## **Addendum No. 4**

### **South Dade Regional Library Interior Renovations**

**C23-MDPLS-01-ESP**

**ADDENDUM NO. 4**  
16-JAN-2025

Sheet  
A-9

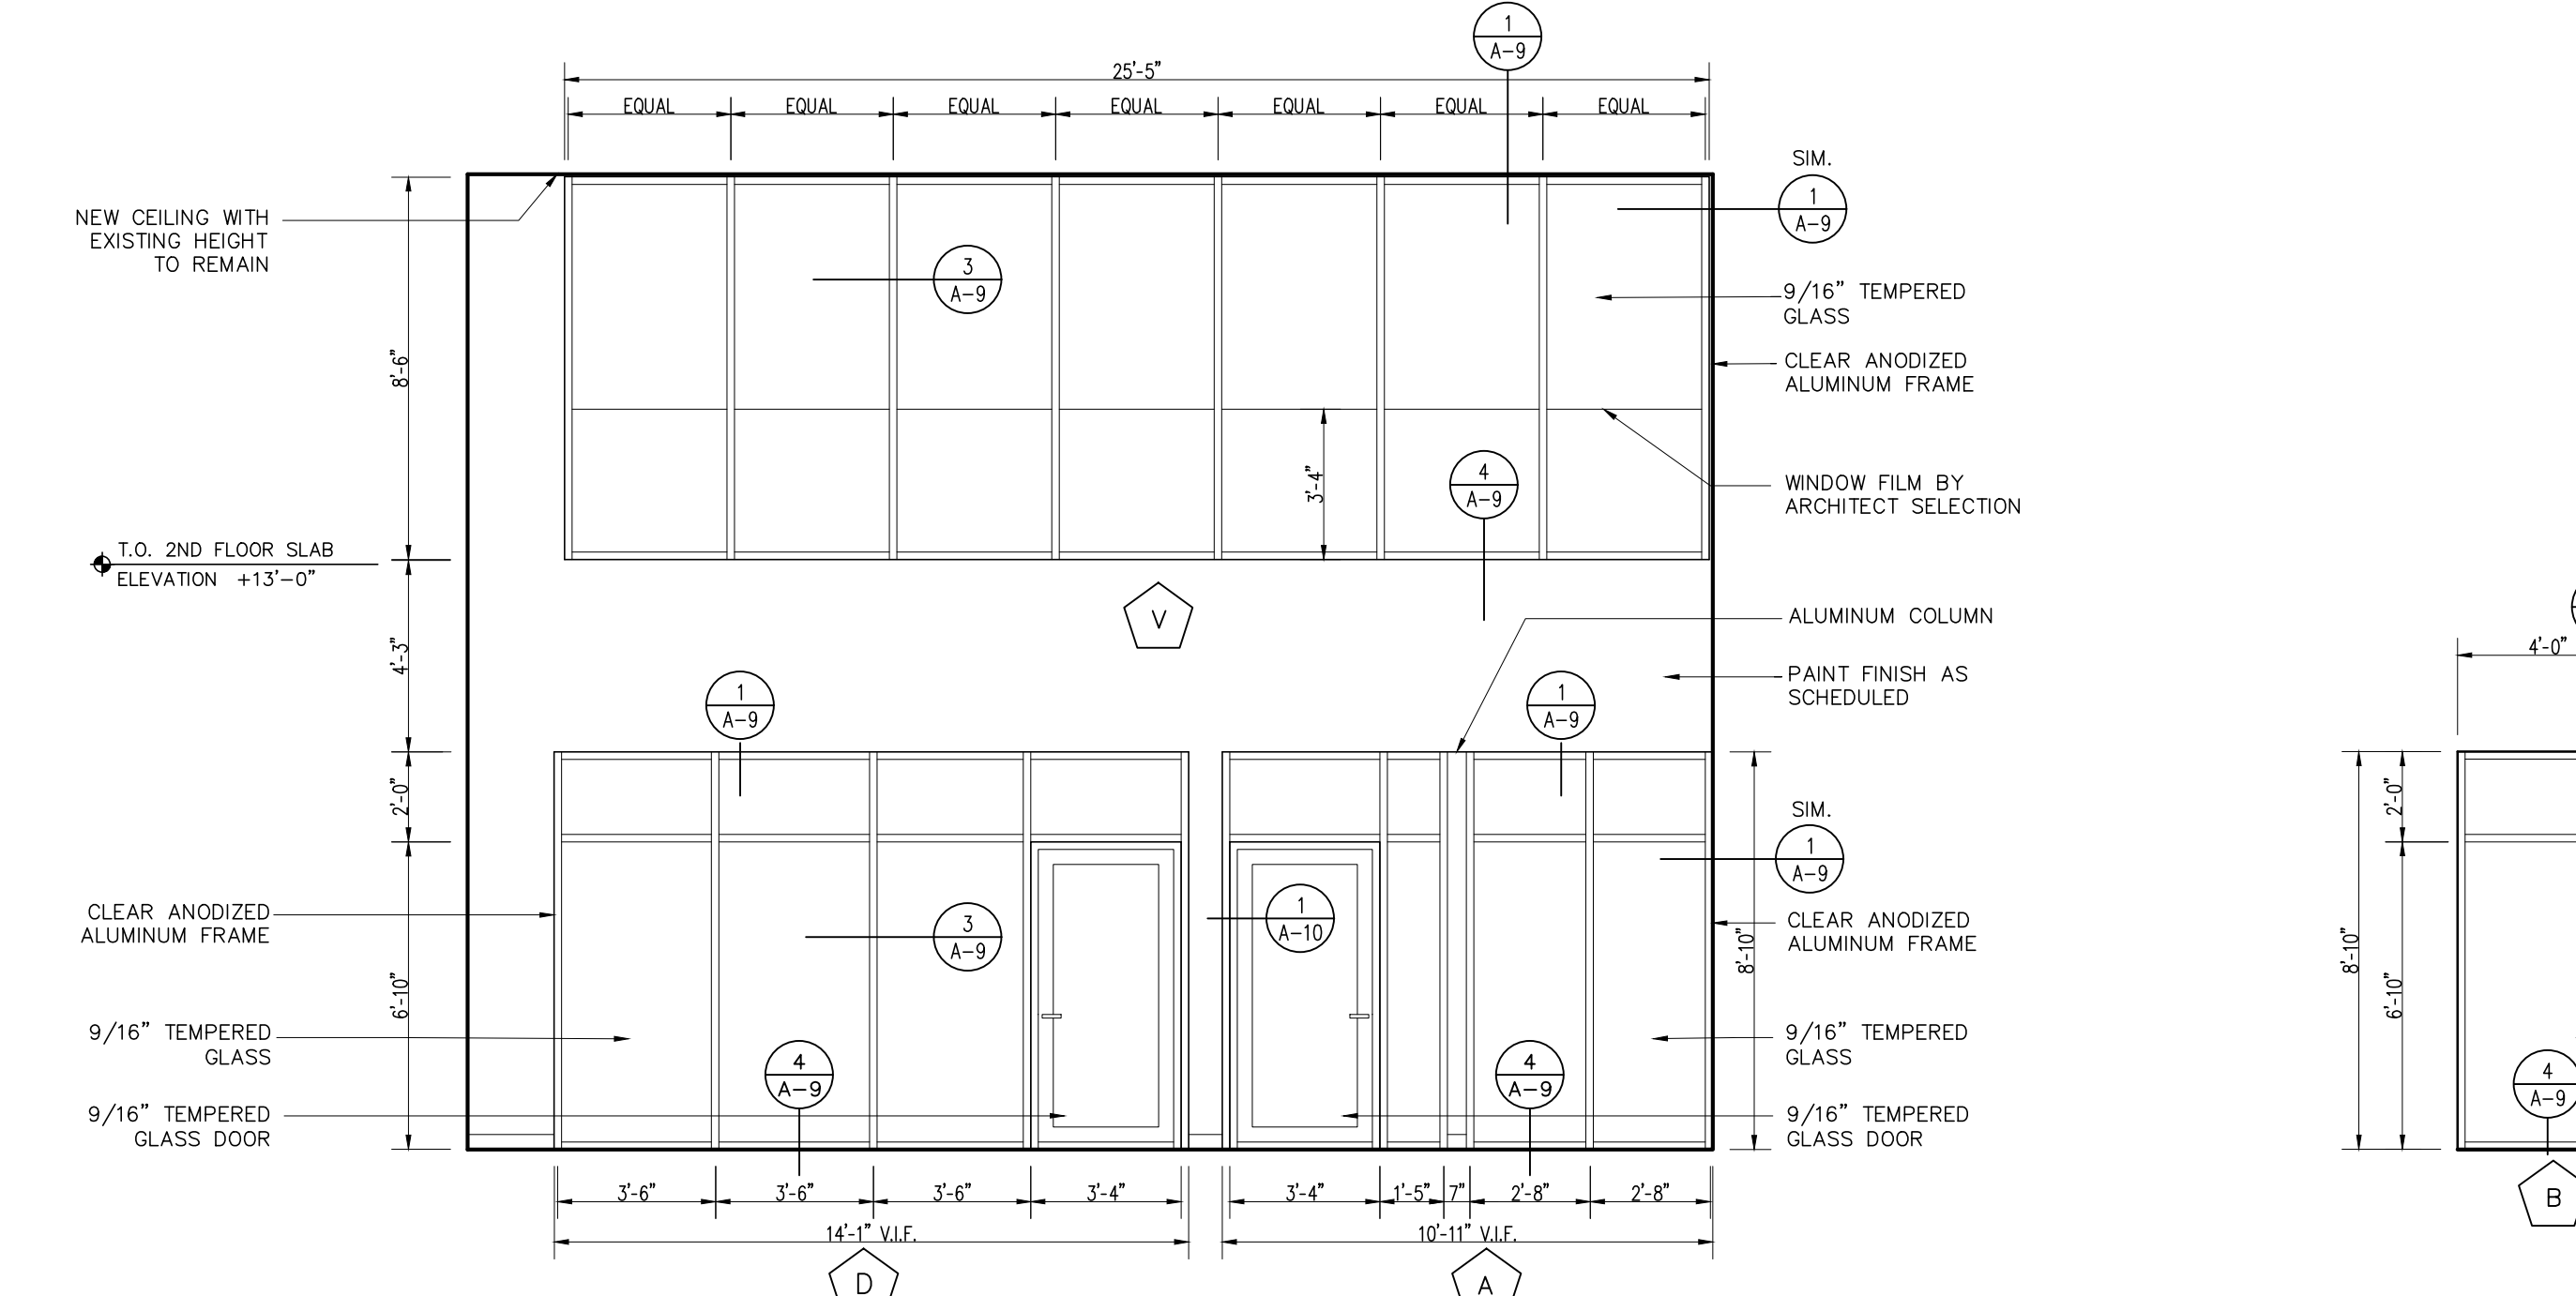
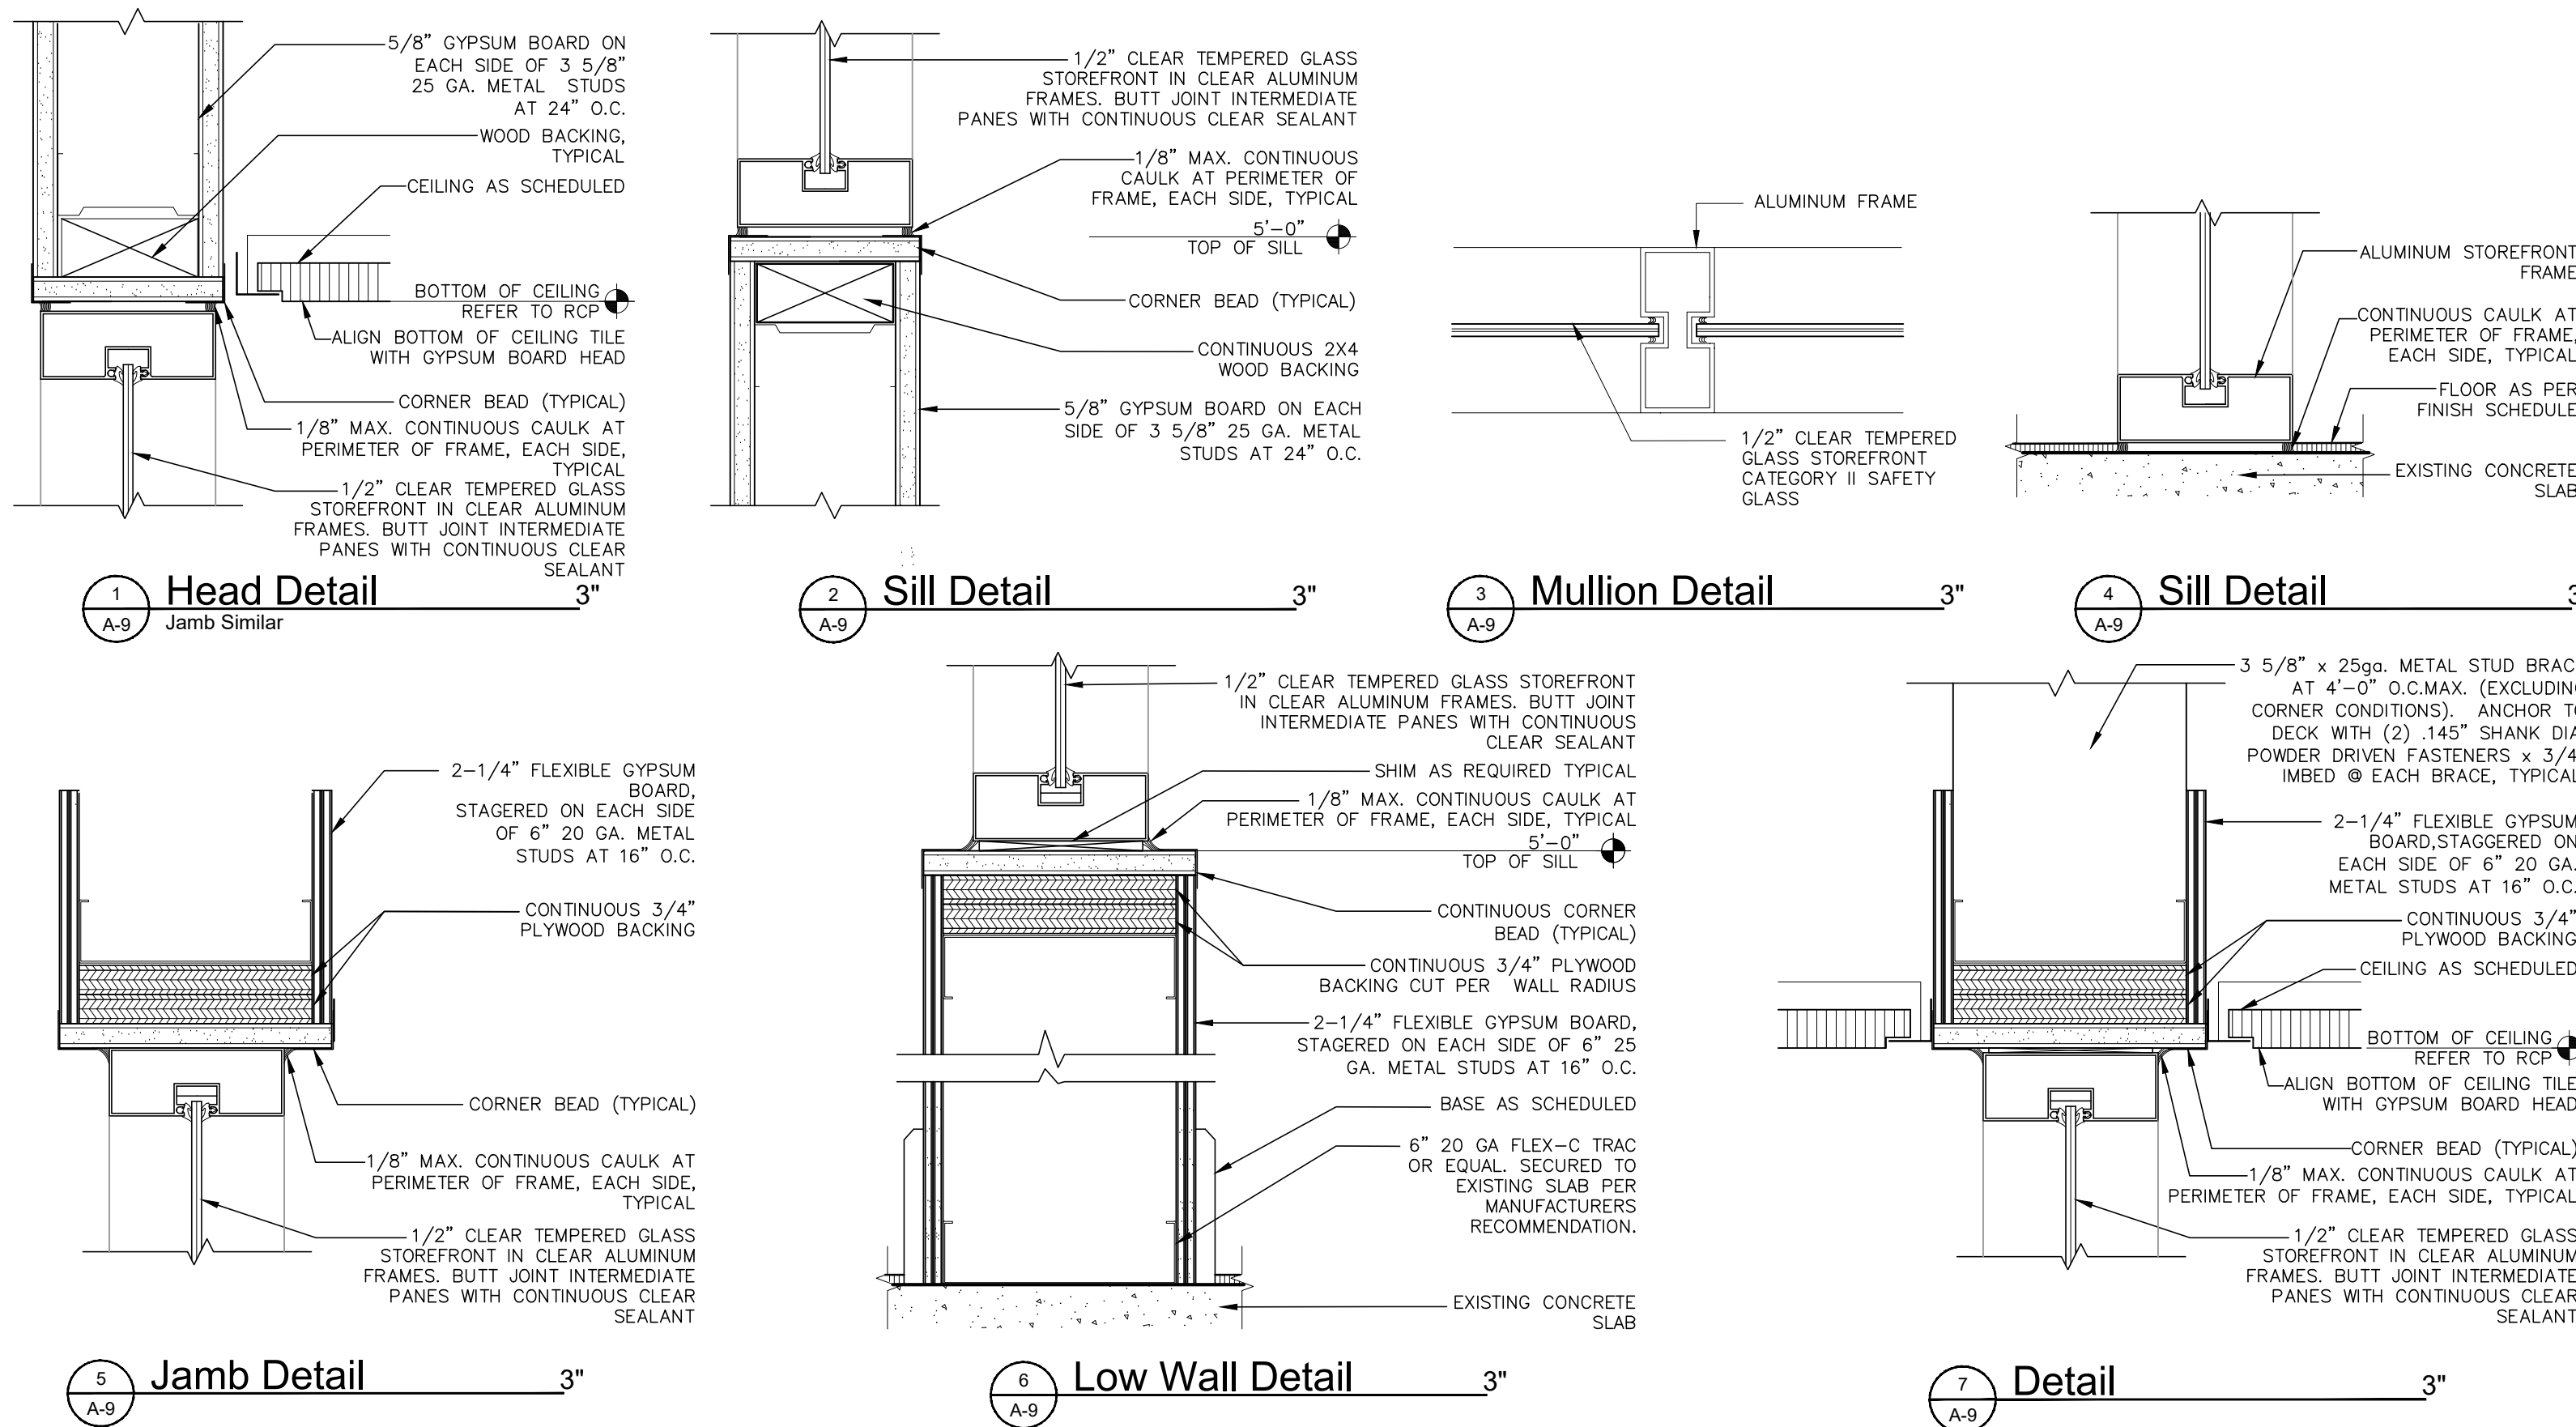
Q47. Plan Sheet A-9 shows the Window Schedule, but it seems to exclude the new Exterior Window shown at plan A-22. Please confirm Exterior window is to be included in Base bid and if so, add to the Window Schedule.

Q48. Plan Sheet A-9 shows an interior window Mark V with a partial window film to be selected by architect. Applied only to 40” high? Please clarify if the film is to be included in Base Bid and if so, provide a specific film selection and color/finish.

**Response Q47. Exterior window should be included in the Base bid. Refer to revised sheet A-9, Window Schedule and window mark on A-1 First Level Floor Plan.**

**Response Q48. Yes, film to be included in the Base bid. Film by Design Film, SKU: DF-GF3-30\_100 or similar. GC to provide samples for client and architect approval prior to ordering.**
